Comments to

**Draft Environmental Impact Statement
for the
Gilberton Coal-to-Clean Fuels and Power Project**

**Mike Ewall
1434 Elbridge St
Philadelphia, PA 19149
215-743-4884
catalyst @ actionpa . org**

February 8, 2006

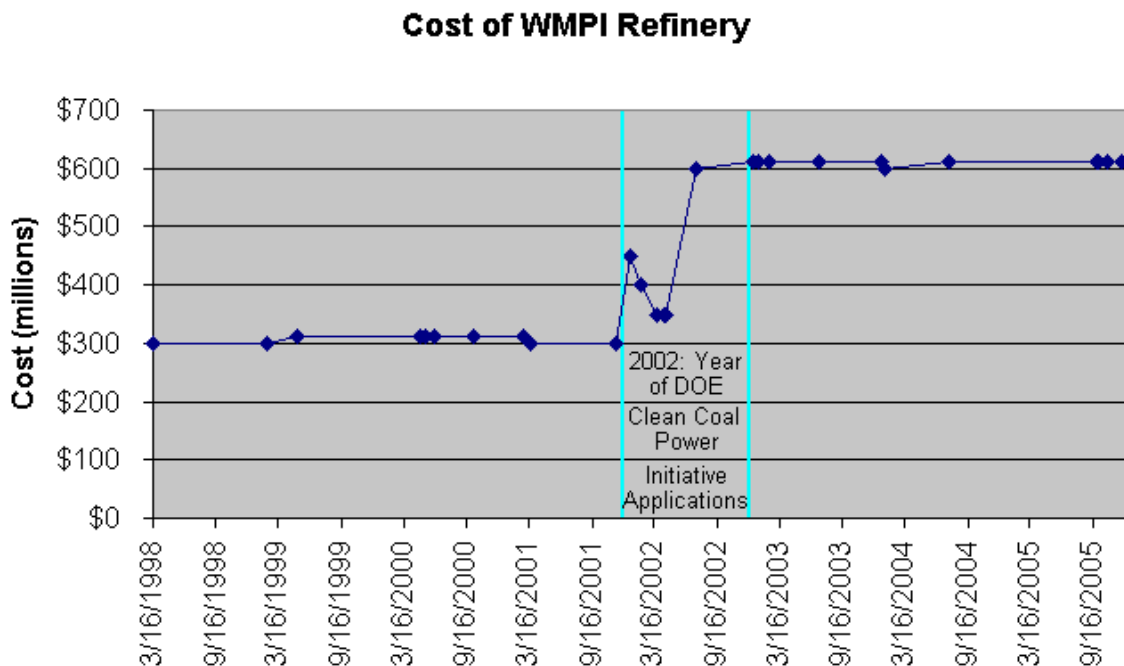
The DEIS states that the decision is whether to fund the project with "\$100 million (about 16% of the total cost of approximately \$612 million)" [xvii]. The projected total cost of the refinery jumped from \$300-312 million to \$612 million in the year that WMPI applied to DOE for this funding. This issue was raised in the scoping comments but went unaddressed in the DEIS.

No explanation has been given for this near-doubling of project costs and it seems that this increase ought to be properly justified so that DOE can assure that no fraud is perpetrated on federal taxpayers and so that the project can be properly evaluated with regard to the 75% cut-off for repayment. The DEIS doesn't mention this 75% cut-off and ought to be clear about how this cut-off affects the applicant's obligation for repayment.

The following chart is based on the stated costs of the refinery in over 30 news articles since 1998. Citations of articles for each data point are available online at: <http://www.ultradirtyfuels.com/projectcost.html>
